ADDENDUM #02

**Monterey Regional Waste Management District
MONTEREY PENINSULA LANDFILL
MONTEREY COUNTY, CA**

RE: MODULE 7 PHASE 3 – EXCAVATION AND LINER – RESPONSE TO BIDDER QUESTIONS AND INQUIRIES

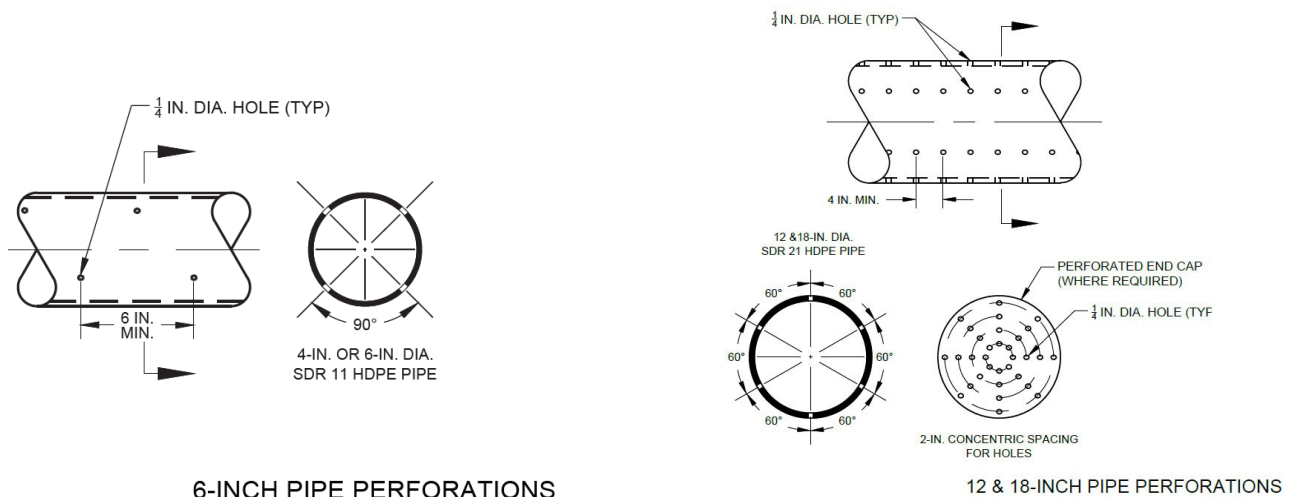
30. What are the dimensions for the underdrain trench shown in detail 4 on sheets 7 & 8 ?

Approximate dimensions are 2 ft deep trench with 2H:1V sideslopes.

TITLE
MODULE 7 BASE GRADING PLAN

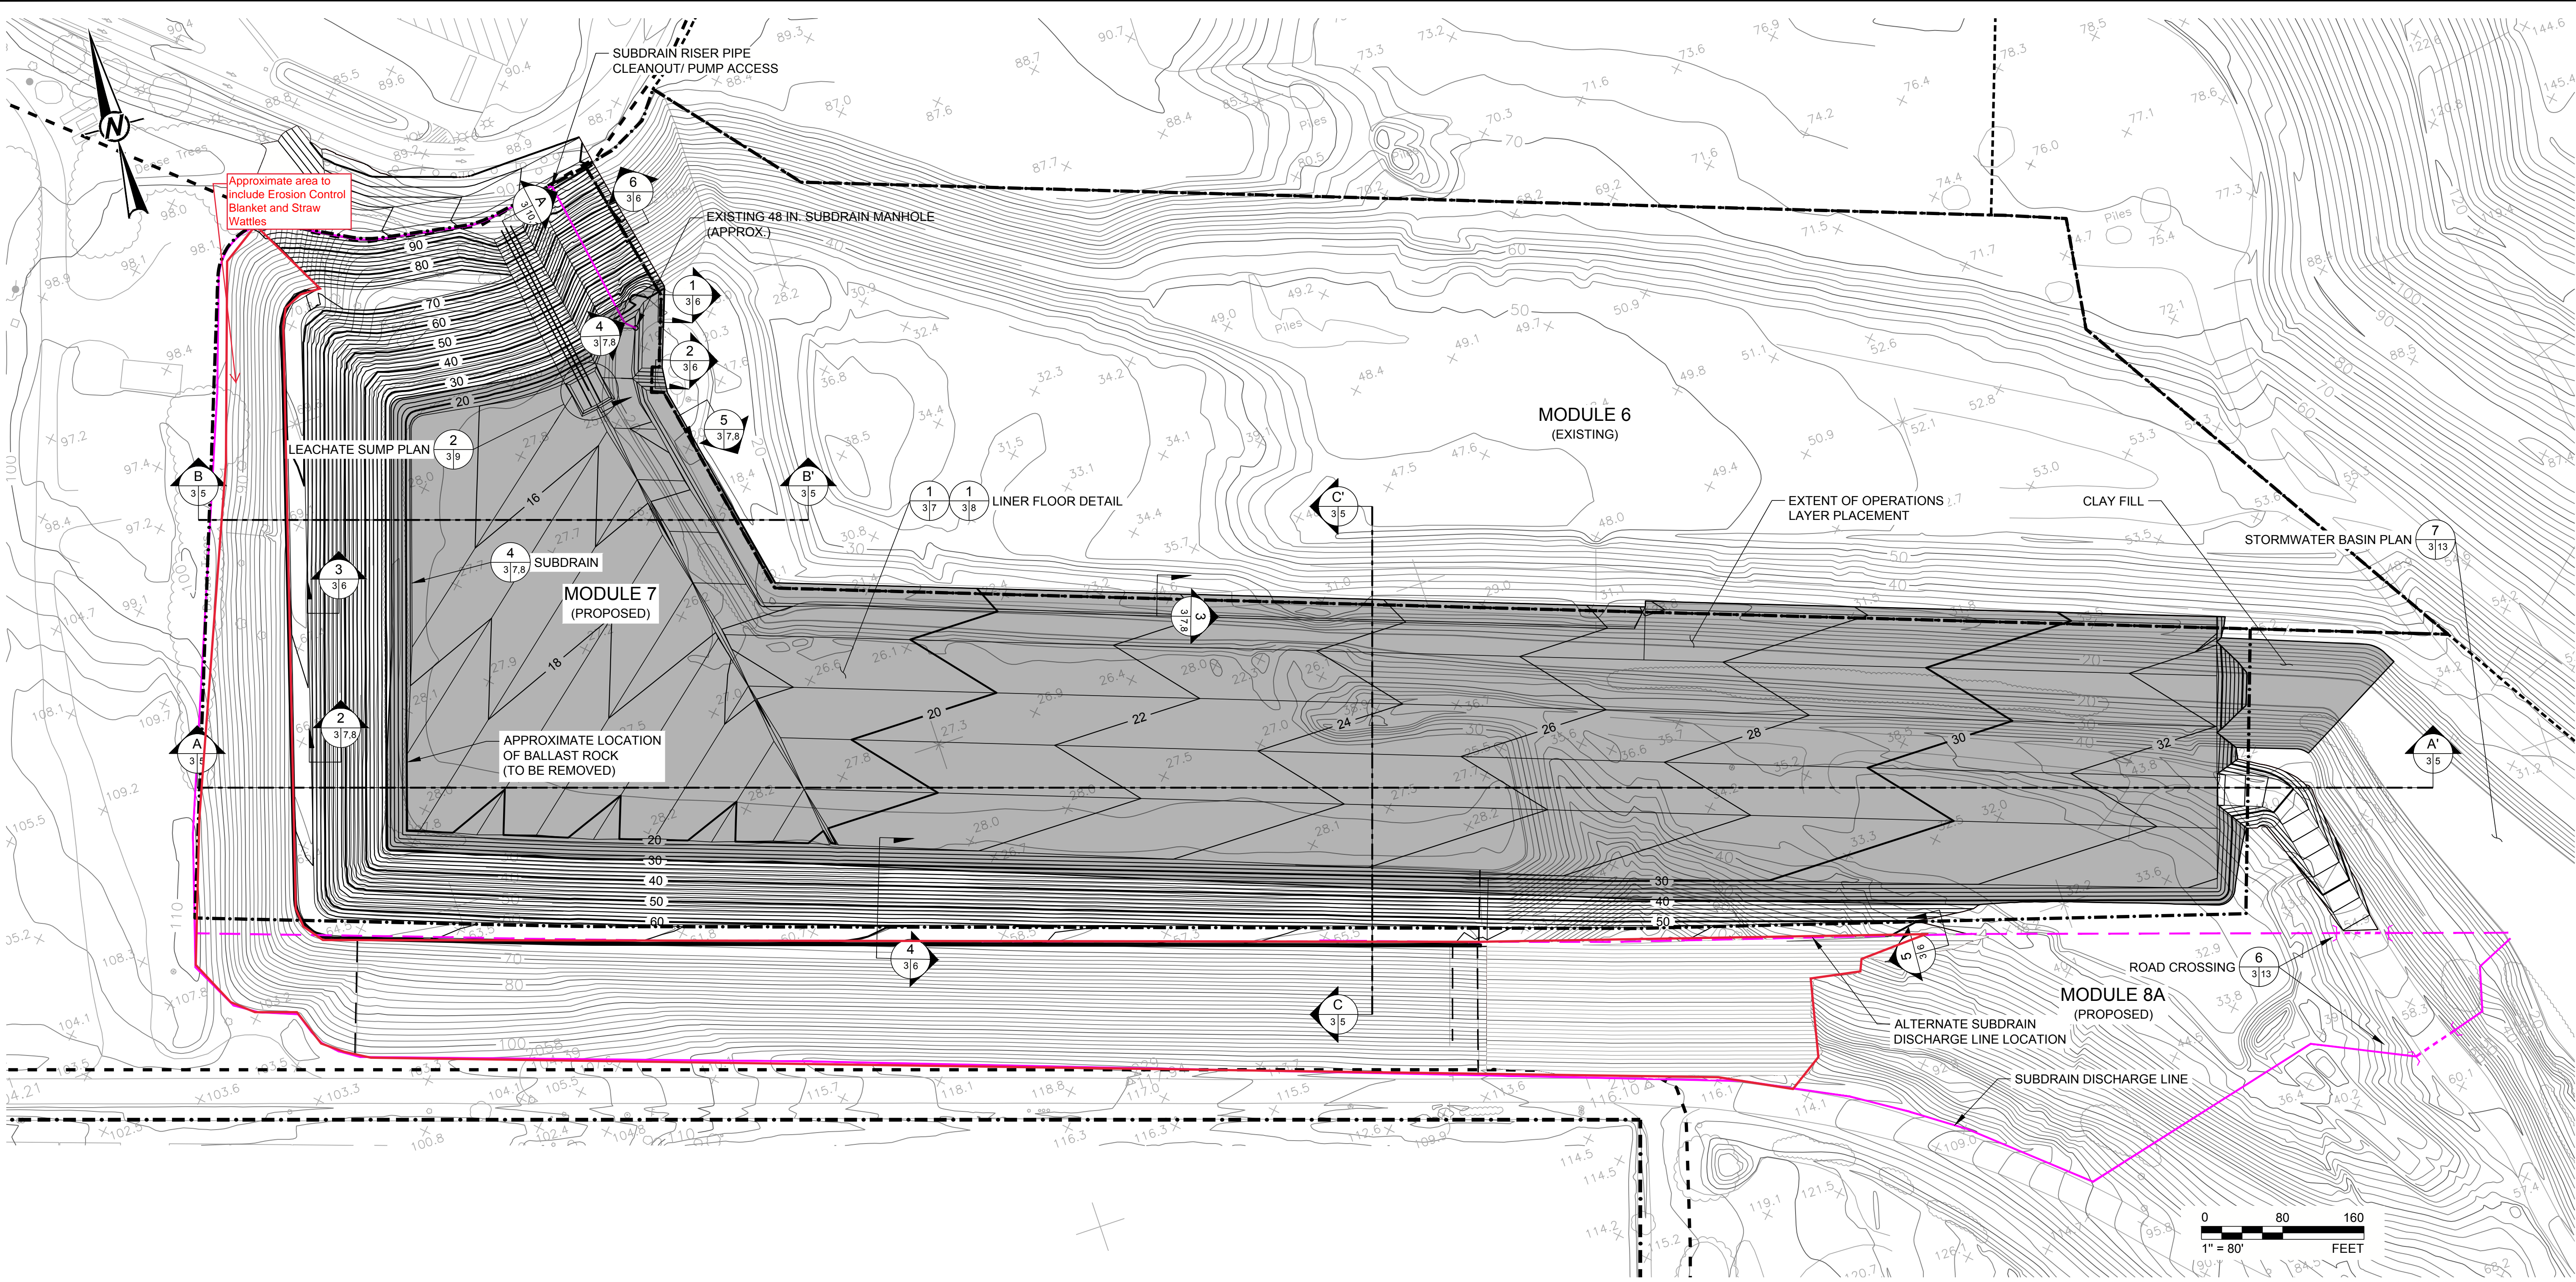
19. I am unable to find the location or specific details for the Wet Well Extension. Perhaps it may be referred to as something else in the Contract Documents. Can you provide this information and / or provide clarification on the Wet Well Extension?

33. Please provide location & details for Bid Item 38 – Wet Well Extension.

The existing wet well is a Jensen precast manhole with a 48-inch ID, approximately 11 feet high, with a (concrete) sidewall thickness of approximately 5 inches. This manhole will remain in place but be tapped with a 12-inch diameter HDPE subdrain riser pipe aligned as presented on Sheet 3.

See response for item 19.

TITLE
MODULE 7 STOCKPILE PLAN

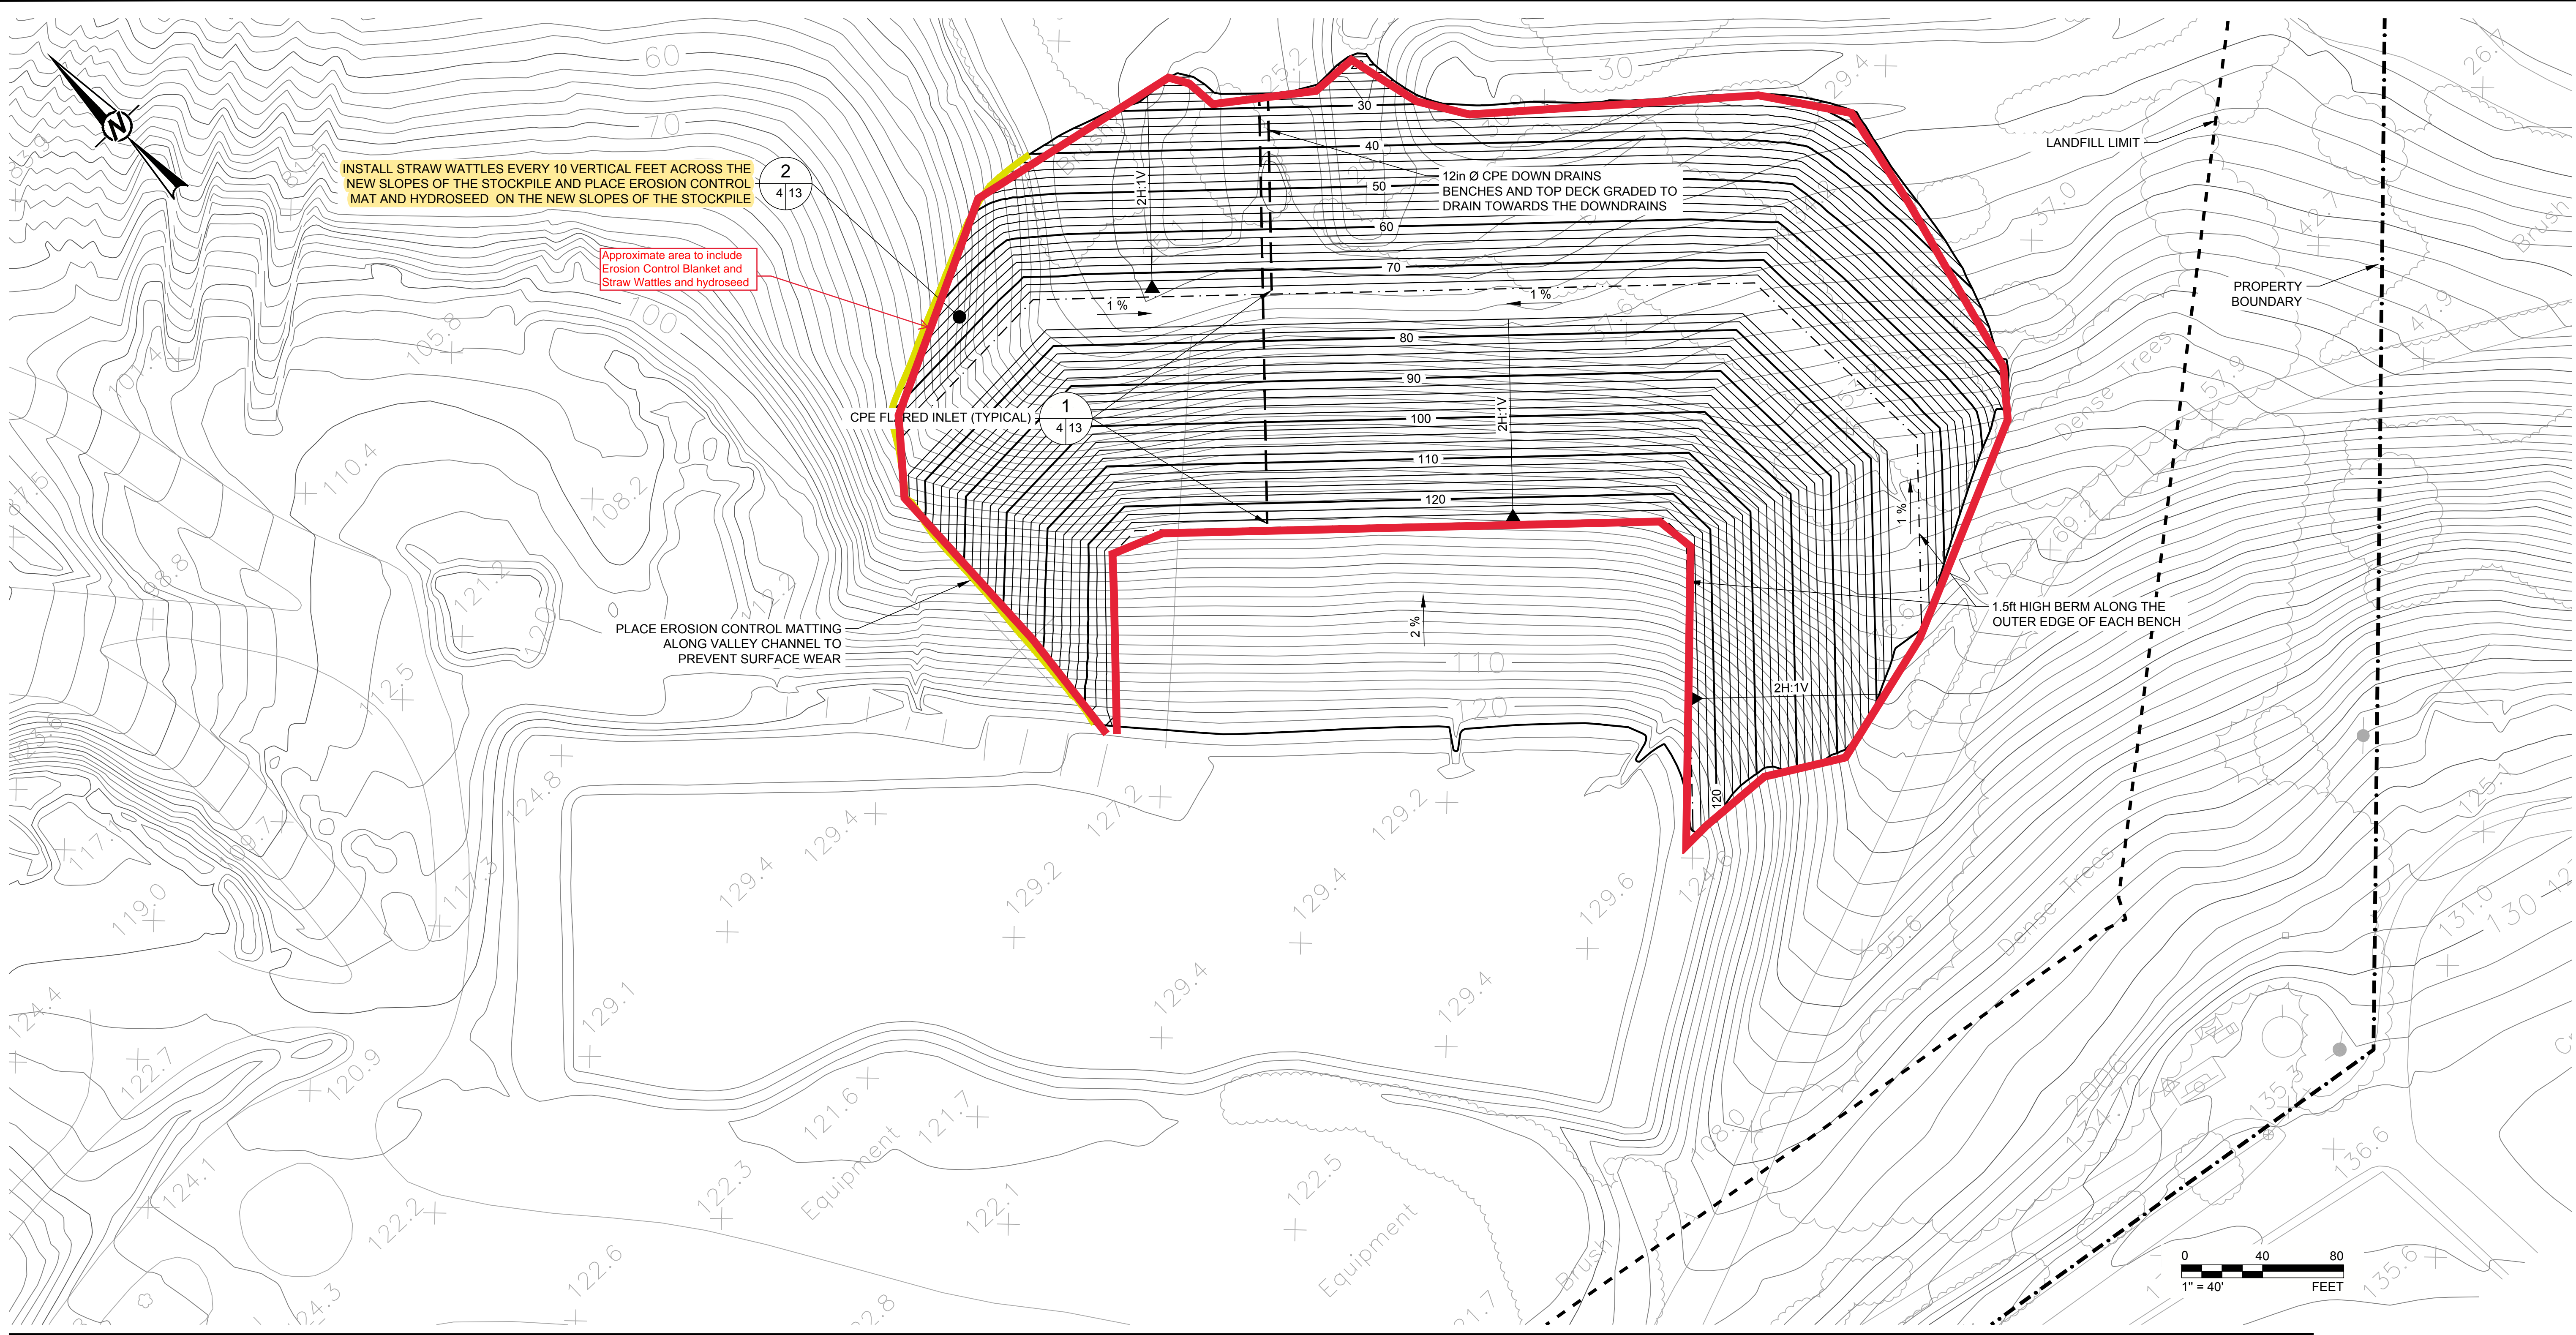
38. There are no specific erosion control plans, can you clarify areas to receive specific treatments. This affects the amount of fiber rolls to be installed with E/C Blanket based upon the amount of slope and size.

See Attached Figures for delineated areas for erosion control blanket, straw wattles and hydroseed. The outlined unlined slope and stockpile slopes shall receive blanket and straw wattles, which is accounted for in item 33 quantity. The area to be receive hydroseed are the new stockpile slopes as shown on drawing 4, which is item 34

See previous answer. Stockpile receives erosion control blanket, straw wattles and hydroseed as stated on drawing 4.
